Thickener Area Mini-HAZOP Report

H354600-3310-142-066-0001

A Mini Hazard and Operability Study (HAZOP) Study was conducted for the thickener area for Project Lucy 2.0 Phase 1 on 10 September 2020. The HAZOP record is provided in Appendix C.

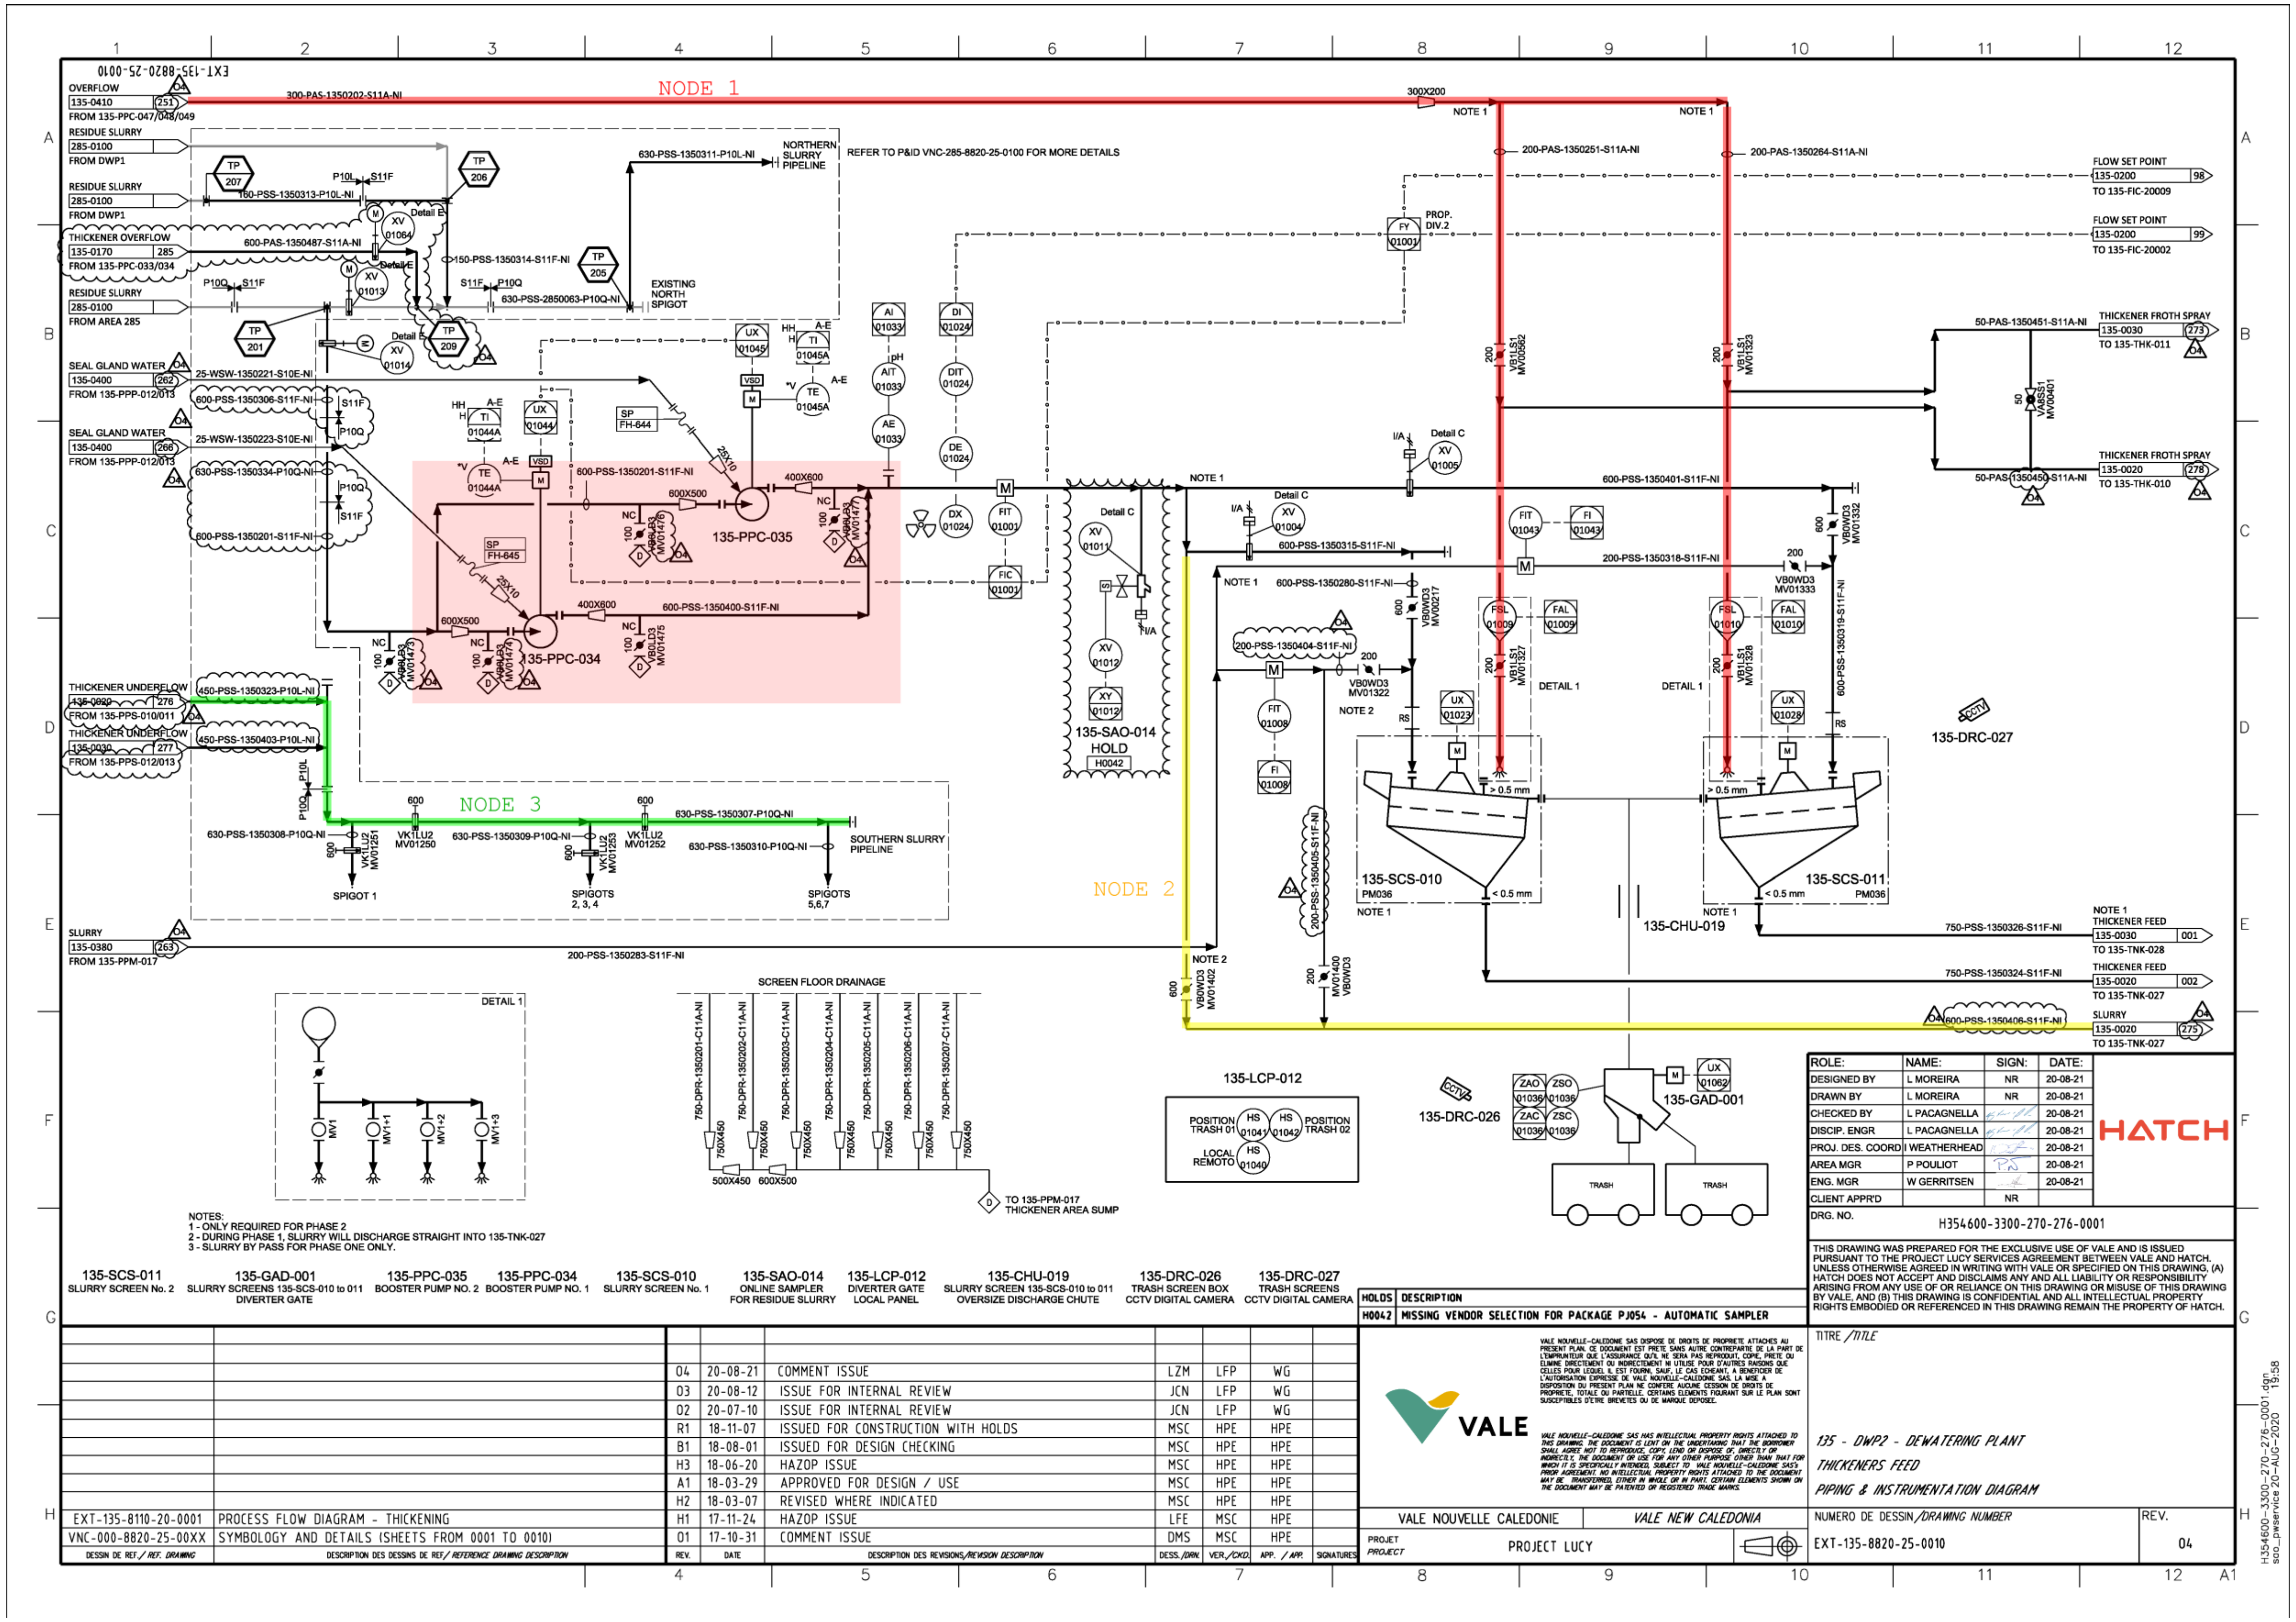
Node	Deviation	Cause	Consequence	Effective Safeguards	Recommendations	Responsibility
1. Thickener overflow to screen spray wash	1. High Flow – High Level	1. 3 pumps running instead of 2	1. Excess fluid to screens, extra dilution		1. Ensure appropriate pump control in place.	Flore

2. Low Flow - Low Level	1. Not enough water	1. Blocked screen, possible overflow	1. Low flow switch/alarm	2. Calculate condition-based maintenance for sprinklers. Baseline pressure/flow characteristics during commissioning and look for anomalies during operation.	Flore

2. Damage to pumps	2. flow meter after pumps	3. Check whether screen overflow will be directed to bund or bin.	Brett
				3. Pressure transmitter after pumps	4. Consider whether limit switches are required on manual valves to interlock pump start.	Brett

2. Problem with pumps				
		3. Closed suction valve (manual) (similar to not enough water)				
		4. Sprinklers blocked from solids contamination				
	3. Reverse Flow	1. Liquid will flow backwards if pumps stop.	1. Damage to pump	1. NRV has been marked up on discharge of each pump.

13. Volume, Mass	1. Not applicable				
	14. Tension, Current, Frequency, Power	1. Not specific to this node				
2. Screen bypass to thickener feed boxes	1. High Flow – High Level	1. Overflow thickener feed boxes. (Phase 1 has only one thickener operating.)	1. Loss of material	1. Overflow directed to bund

10. Electrical Safety	1. Not specific to this node				
	11. Maintenance	1. Could the line be blocked due to slurry solids settling, especially if a valve is left closed for a long time (especially in phase 2)		1. Flush line using the same procedure as Area 285 lines.	7. Review possibility of blockage of this node (and also existing KO2 line) and flush methods.	Brett

2. Blocked line		1. P&IDs do not currently show all flush points, but they have been added.	12. Verify that KO2 barge pump can provide sufficient flow for flushing.	Brett

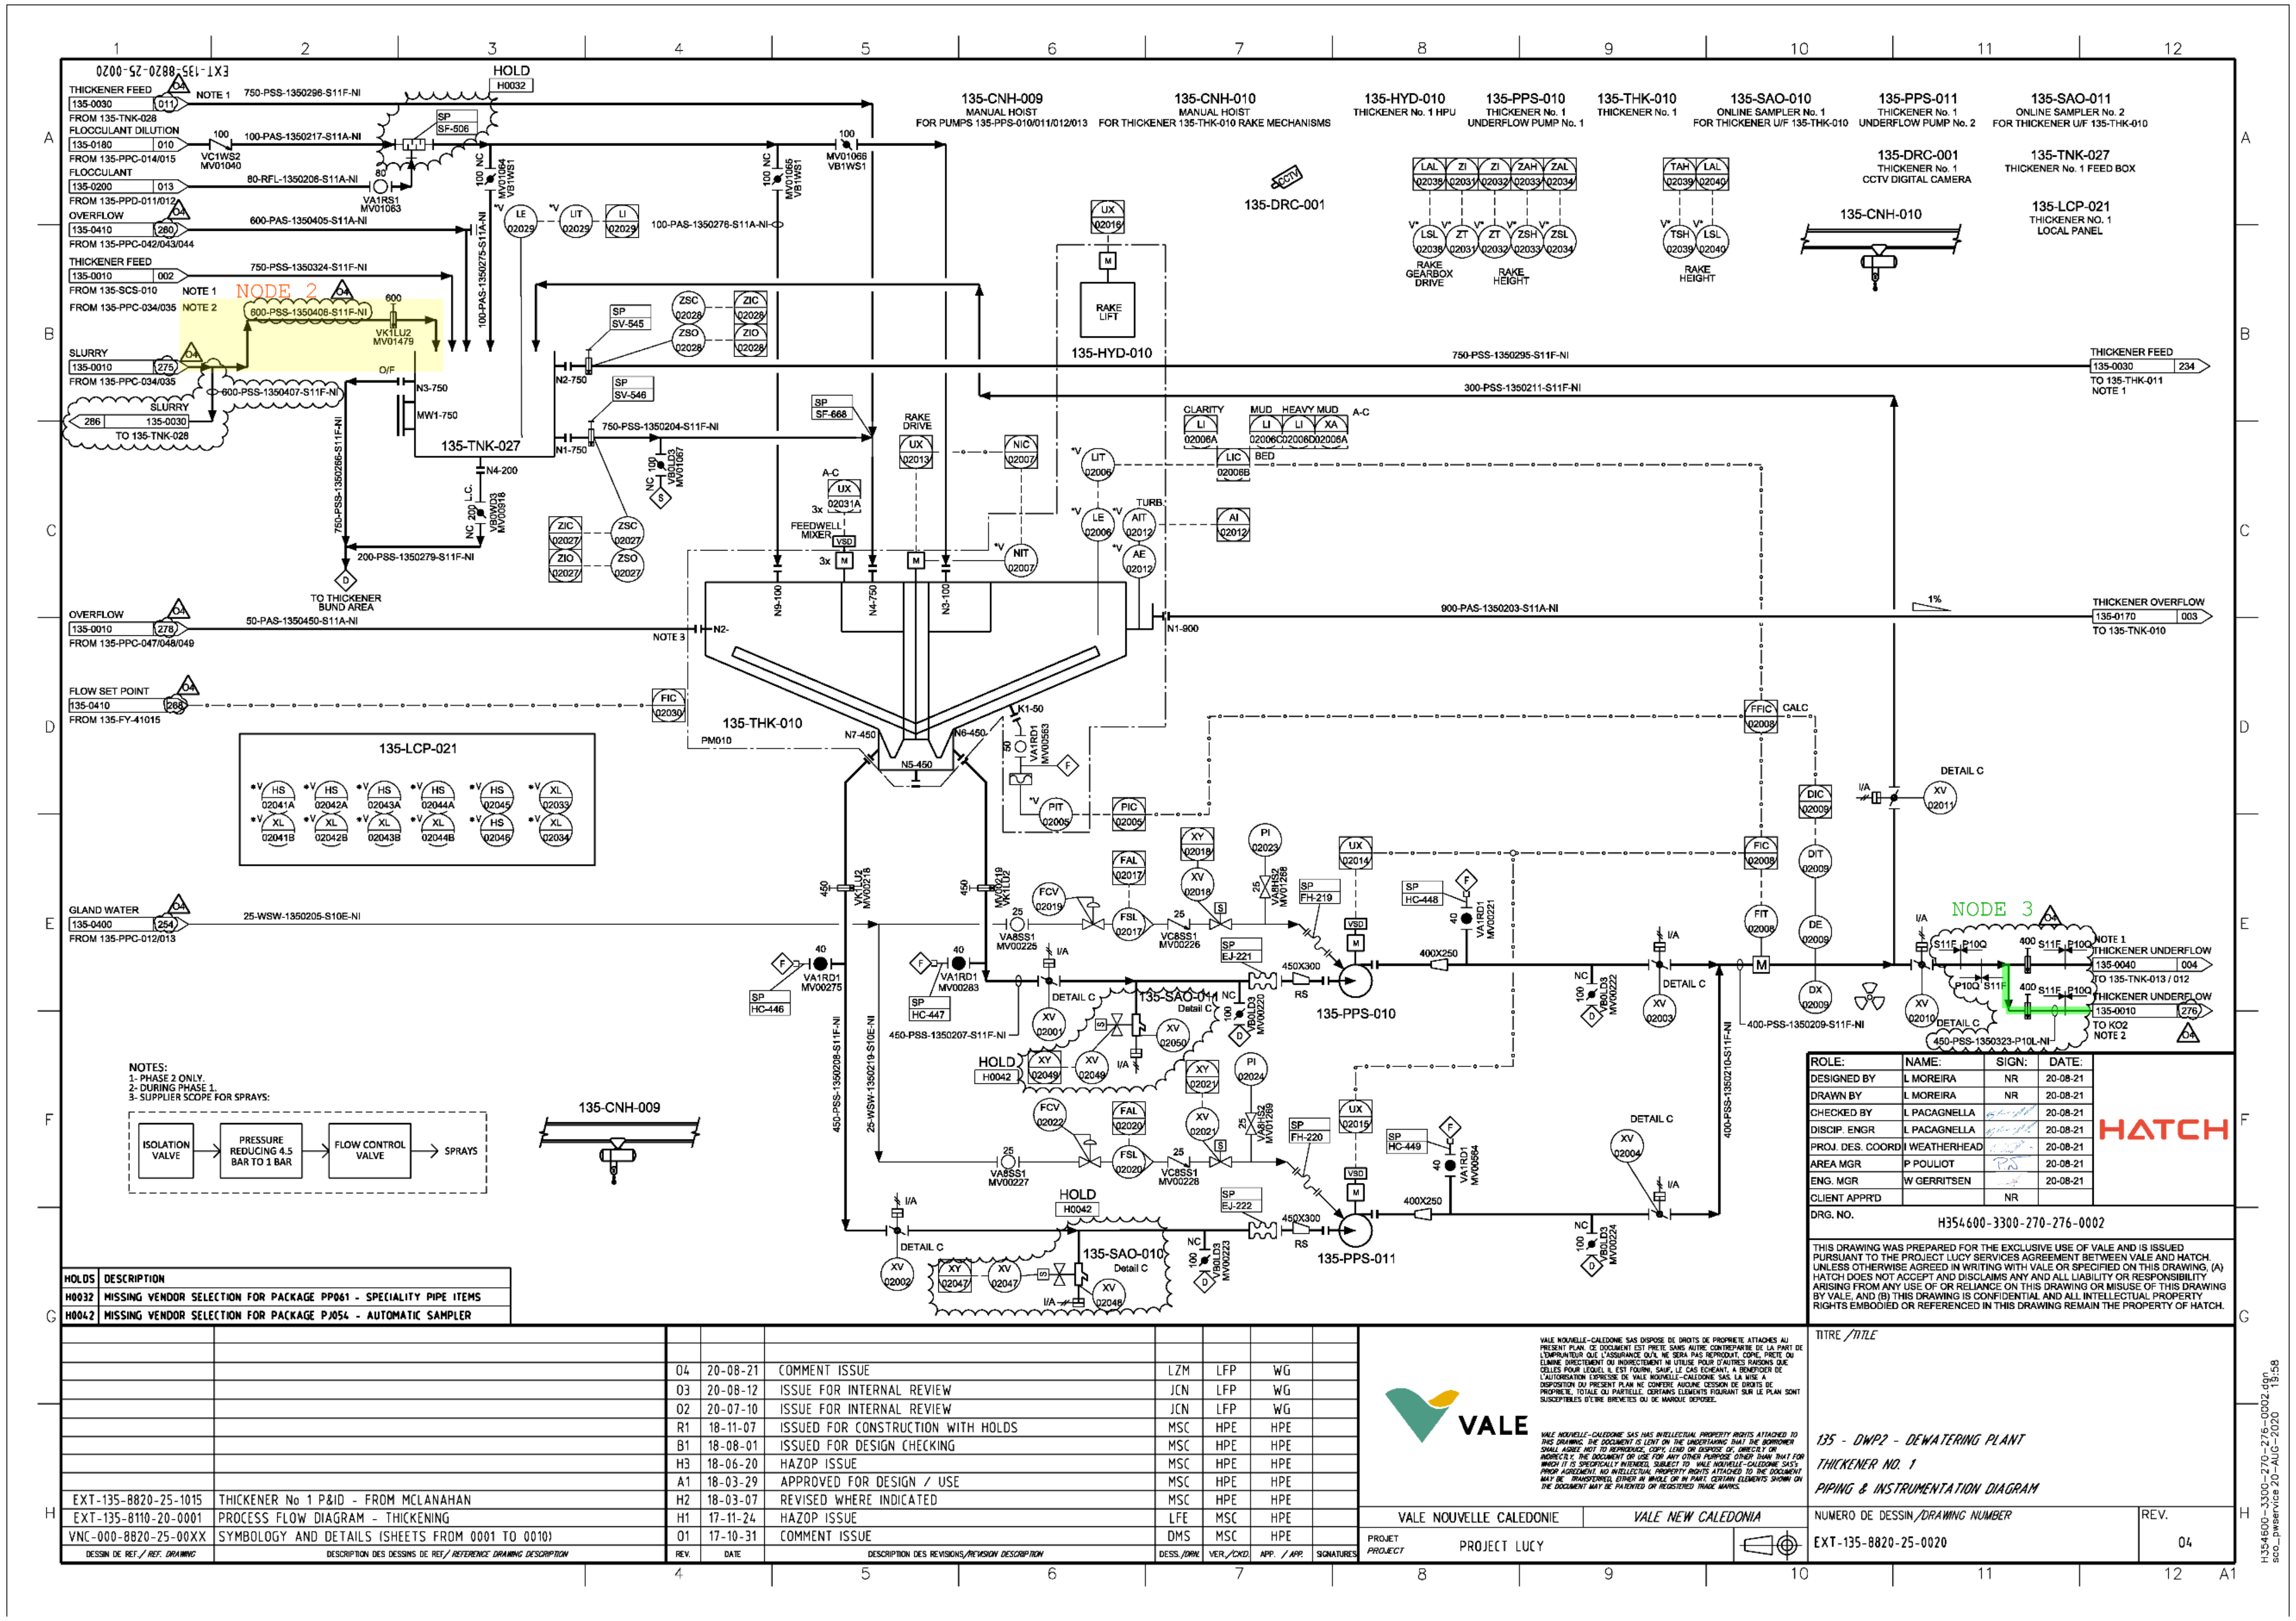
3. Thickener underflow to southern slurry pipeline tie-in	1. High Flow – High Level	1. Siphon		1. There are vacuum breakers in the line	10. Show vacuum breakers on P&ID	Brett

2. Low Flow - Low Level	1. Pump failure. All these causes are similar to Lucy 1.0 - only difference now is that there are two destinations.		1. Flow and pressure transmitters

13. Review of next P&ID version to identify flushing configurations	Brett
		3. Slurry too thick		1. Maximum solids% is 42-45	11. Confirm thickener underflow pumps can handle this level of solids.	Brett
